TITLE PERCOLATION CERTIFICATION PLAN REVISION AND PLOT PLAN		OWNED/BUILDER: Approved Septic System Plan Howard County Health Department Columbia, MD 21046		PROPOSED ELEVATIONS: TOP OF BENCHMARK IN AIR: 424.20 TOP OF FOUNDATION WALL: 424.00 TOP OF FIRST FLOOR: 424.00 BRIGHT OUT OF HOUSE: 424.07 BRIGHT SETS FINE: 424.00 BRIGHT OUT OF TANK: 424.07 BRIGHT SETS FINE: 424.00 BRIGHT OUT OF PLUMB: 424.00 BRIGHT SETS DISTRIBUTION BOX: 424.00 BRIGHT OUT OF DISTRIBUTION BOX: 424.00 BRIGHT SETS TRENCH: 424.00	
DATE: 6.12.2008 SCALE: 1:50		PROJECT NAME: 3 Bedroom SFD as shown R. Buck Signature		GRADE AT HOUSE ENTRY: 424.75 GRADE AT SEPTIC TANK: 424.00 GRADE AT PLUMB: 424.00 GRADE AT DISTRIBUTION BOX: 424.00 GRADE AT TRENCH: 424.00 FINISH SPECIFICATIONS: IF APPLICABLE OVER-CALL OR CALL APPROVAL OVER 11' OVERLAY

RE: Revised Perc/Cert Plan
12614 Grovewood Court
Clarksville, MD 21029

Owner:	Shawn and Lusan Abrams 12614 Grovewood Court Clarksville, MD 21029	
Title:	Revised Percolation Certification Plan for 12614 Grovewood Court	
Subdivision:	Preserve at Clarksville Lot 11	
Drawing Prepared By:	RHINE LANDSCAPING, LLC MHC # 21778 PO Box 1556, Sparks, MD 410-442-2445 www.rhinelandscaping.com	
Tax Ma

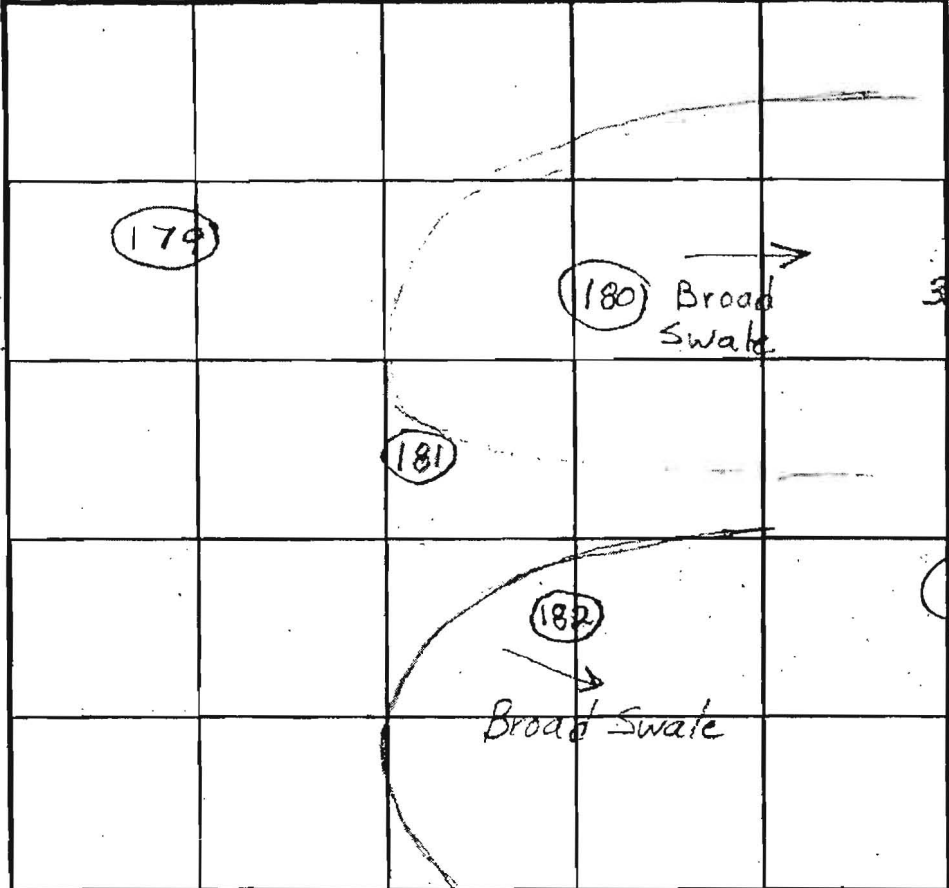
DATE	TEST NO.	DEPTH	PRE-WET		TEST - 1" DROP		TIME	
			START	STOP	START	STOP		
12/11/01	179	5' / 15' V	3:26	3:27	3:27	3:29	2	OK
	181	5' / 15' V	3:34	3:34:35	3:34:35	3:35:35		OK
	Repair	5'	3:37:45	3:38:45	3:38:45	3:40:45	2	
	182	5.5' / 15' V	3:47	3:50	3:50	3:54	4	WS
	* 180	6'-6.5' / 13.5' V	3:59	4:01:15	4:01:15	4:06	~5	WS
		180 and 182 may not be usable located in swales Need to Recheck Topography in Field

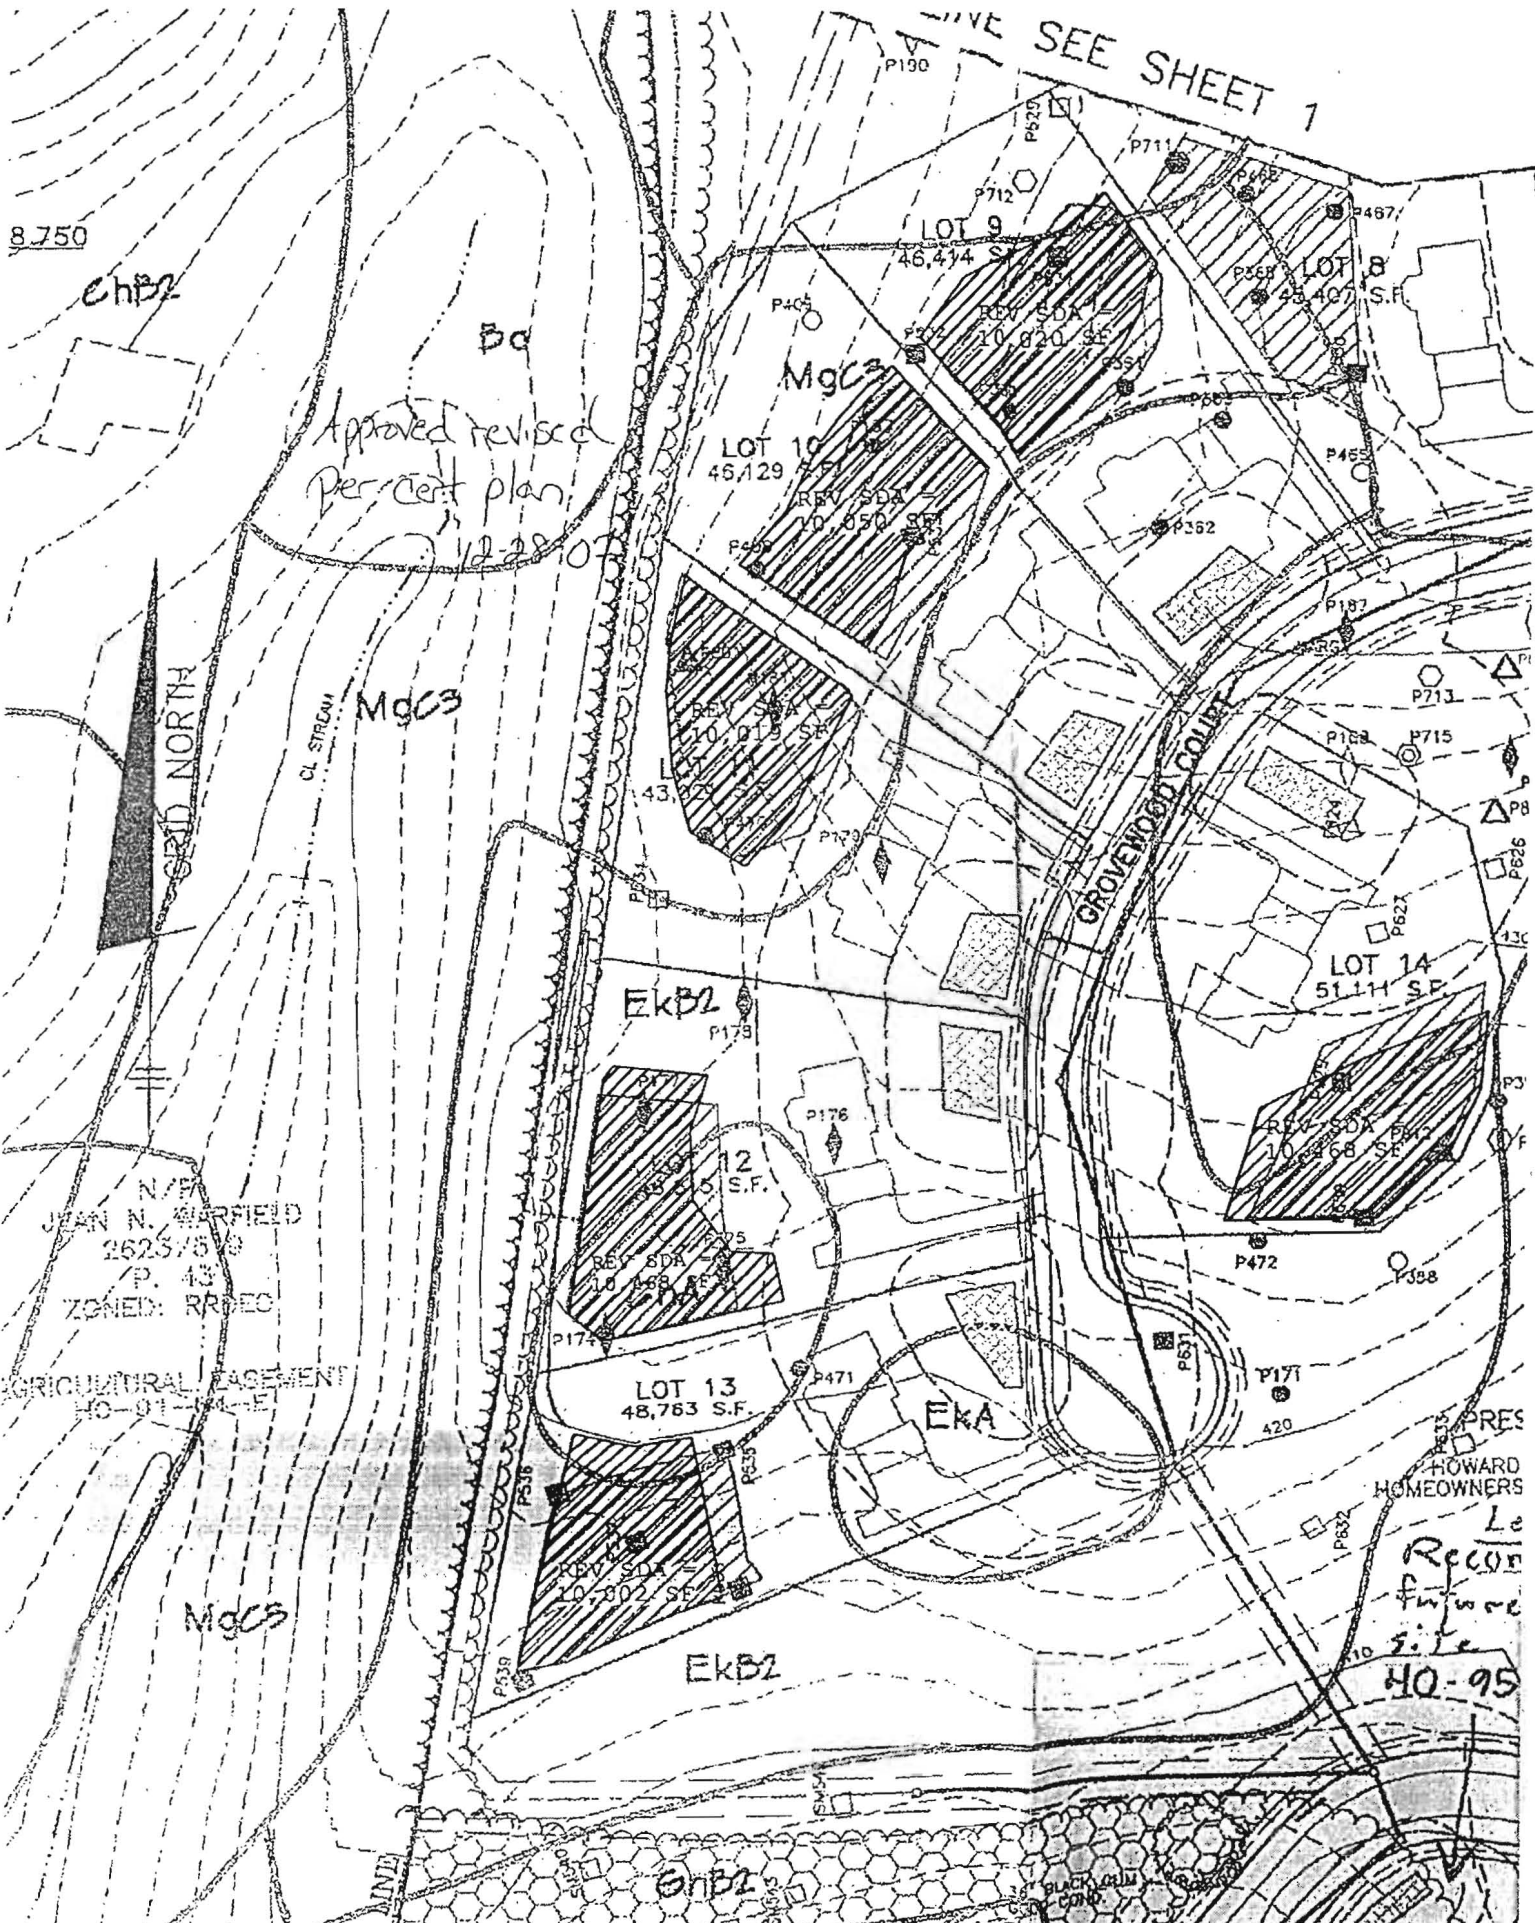
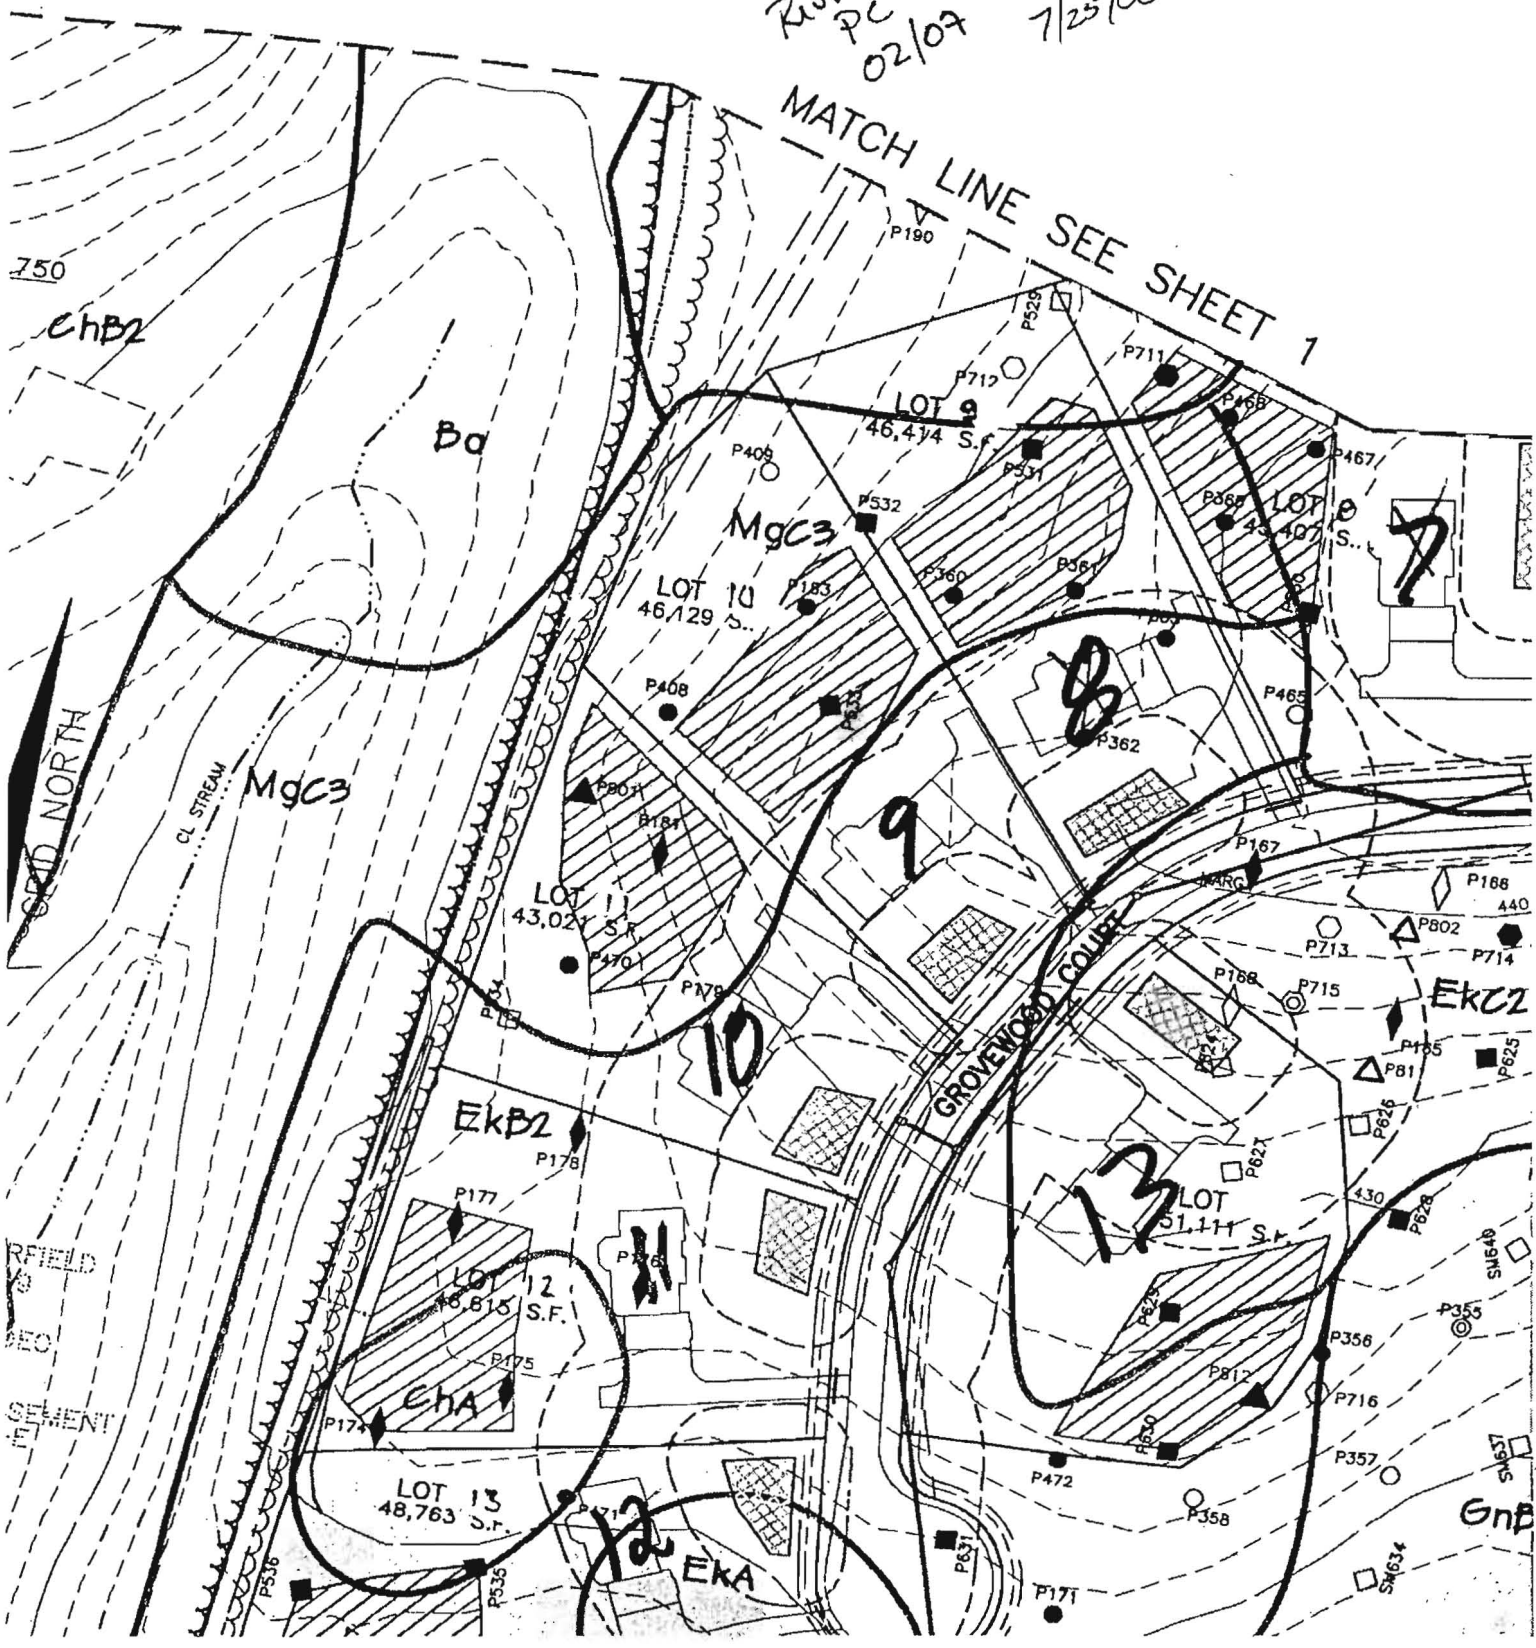
6. THE PURPOSE FOR THIS PERCOLATION CERTIFICATION PLAN IS TO REVISE THE WELL BOX EASEMENT AREA AND REVISE THE SEWAGE DISPOSAL EASEMENT (S.D.E.) IN SUPPORT OF A BUILDING PERMIT APPLICATION FOR THE CONSTRUCTION OF A FOUR-BEDROOM SINGLE FAMILY RESIDENCE. THE REVISED WELL BOX AREA SHOWN MEASURES TO BE 1,500 S.F. THE REVISED S.D.E. AREA SHOWN MEASURES TO BE 10,115 S.F.

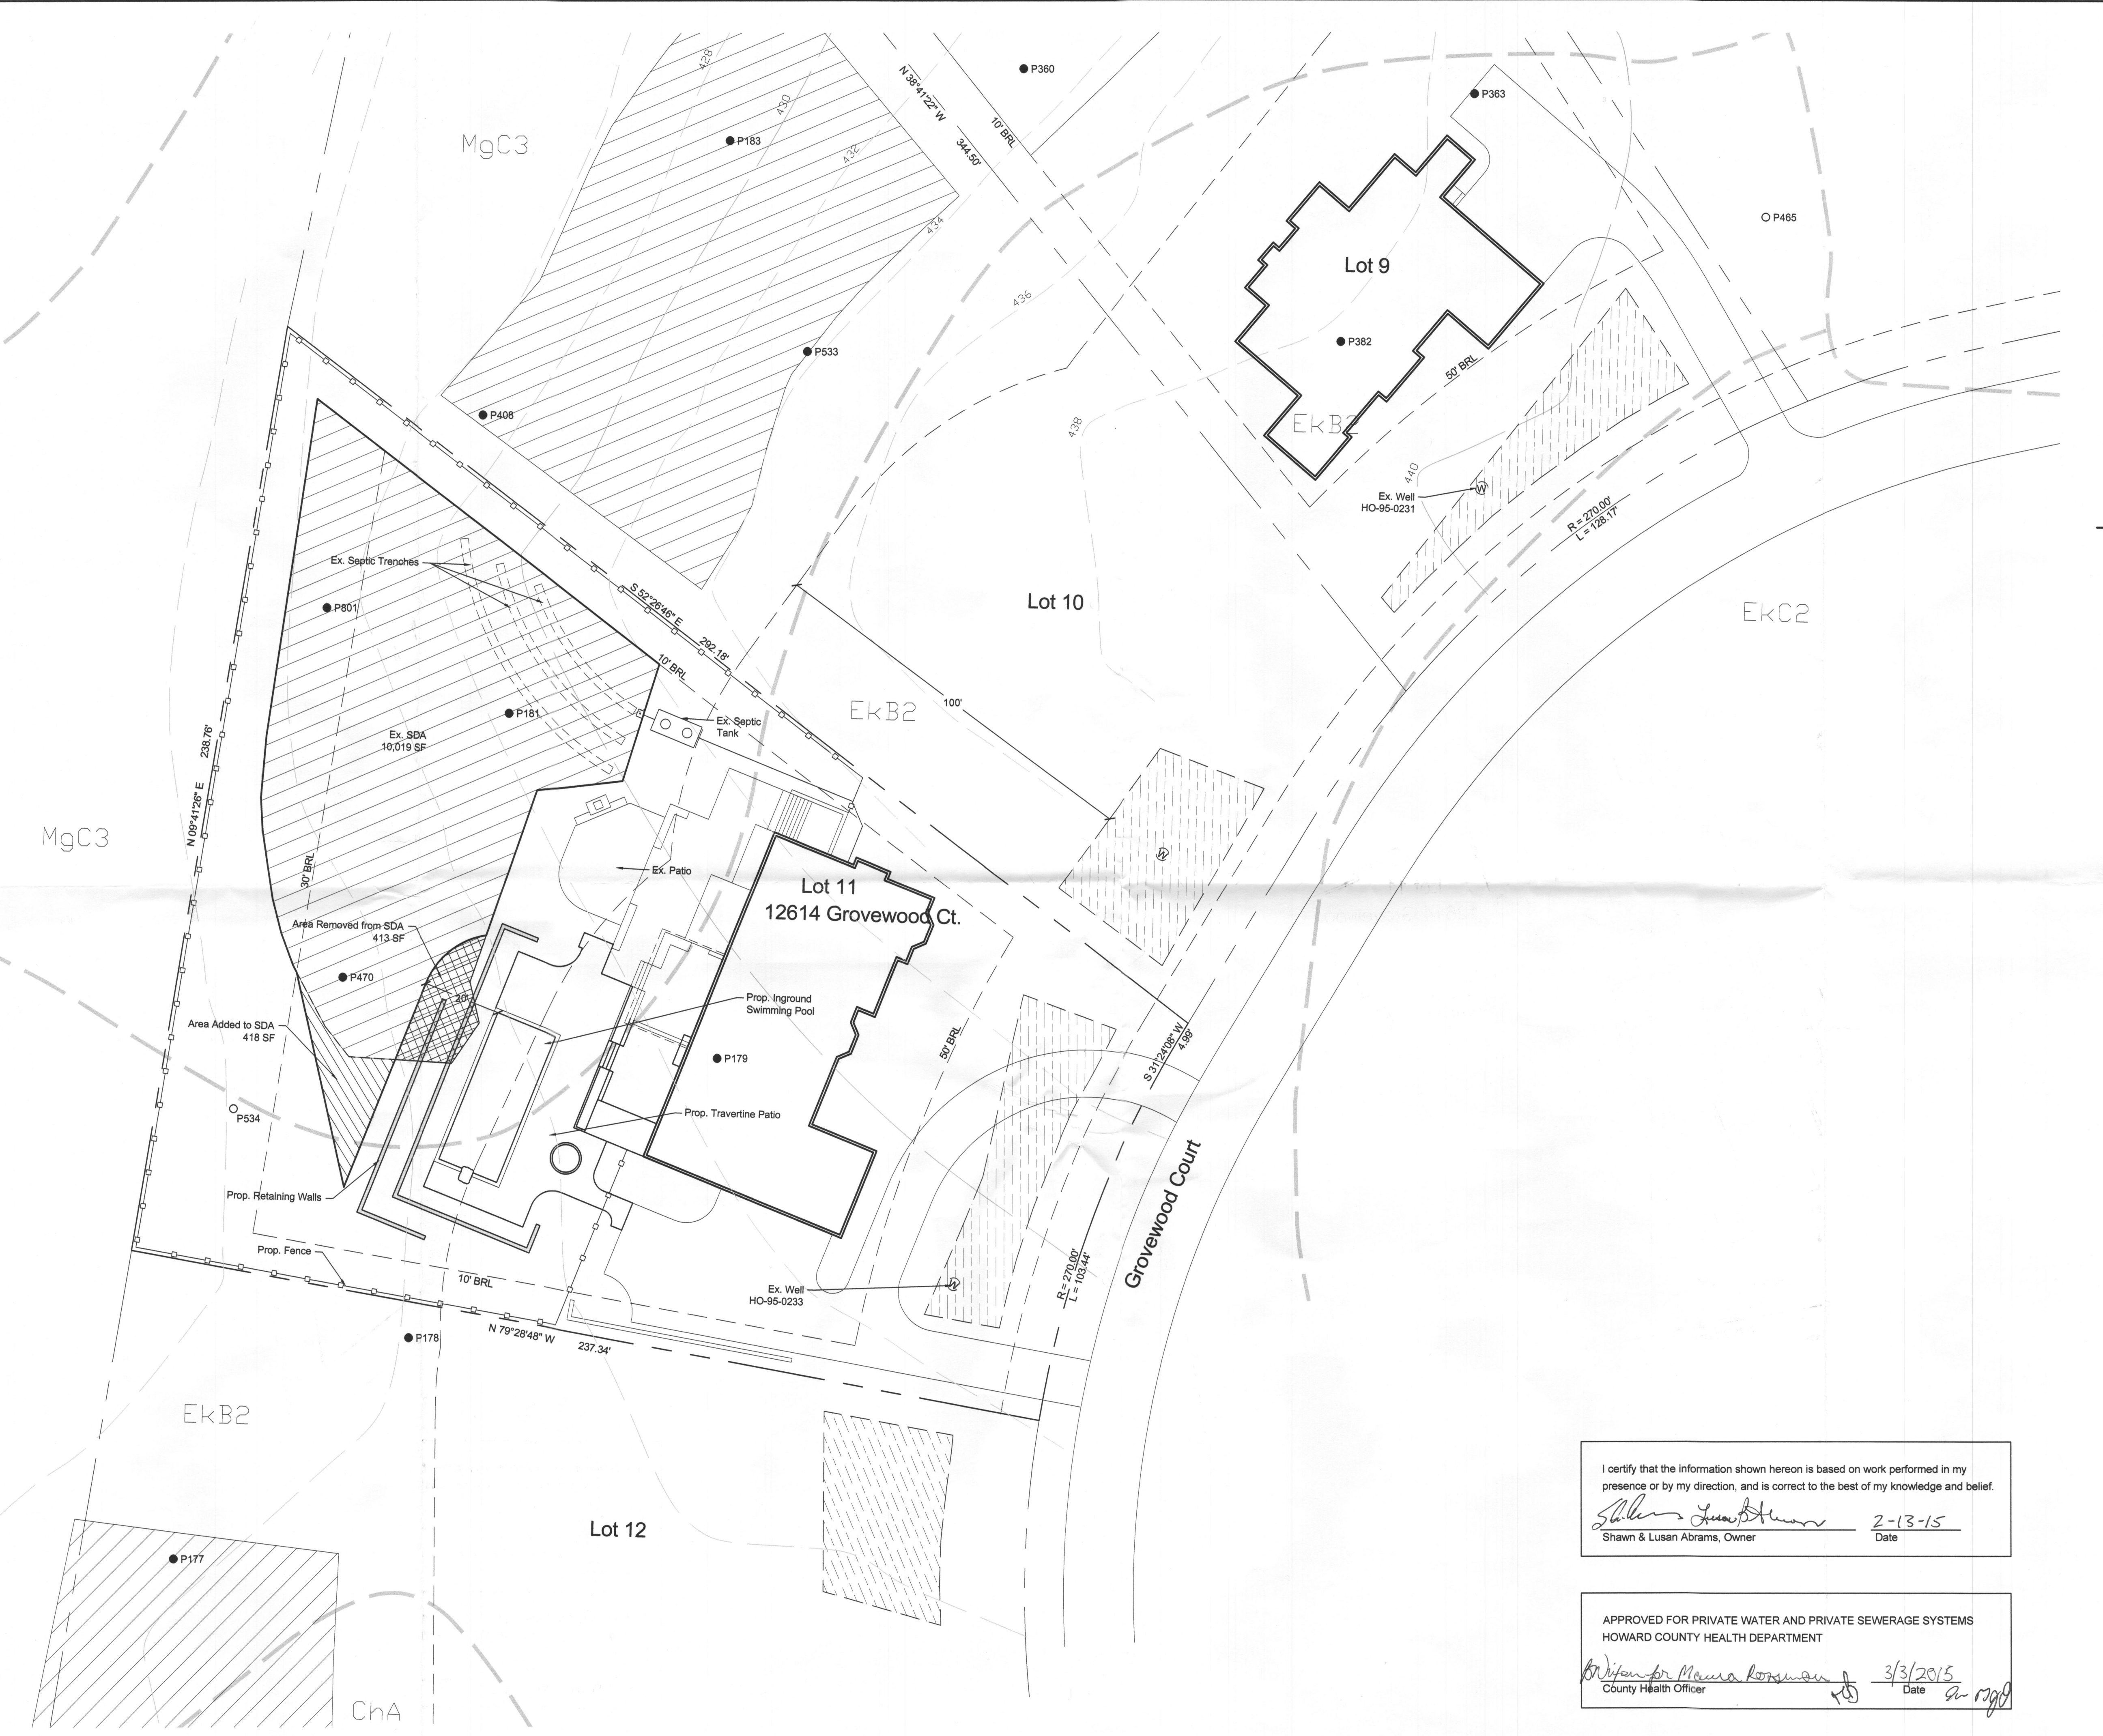
As we discussed during our meeting on February 12, 2015, we made some modifications to the existing septic reserve easement to relocate approximately 413 square feet in order to allow the construction of a new swimming pool with associated retaining walls. We hope that these changes will be acceptable to you.

- The purpose for this Revised Percolation Certification Plan is to adjust the existing sewage easement to accommodate construction of an in-ground swimming pool.
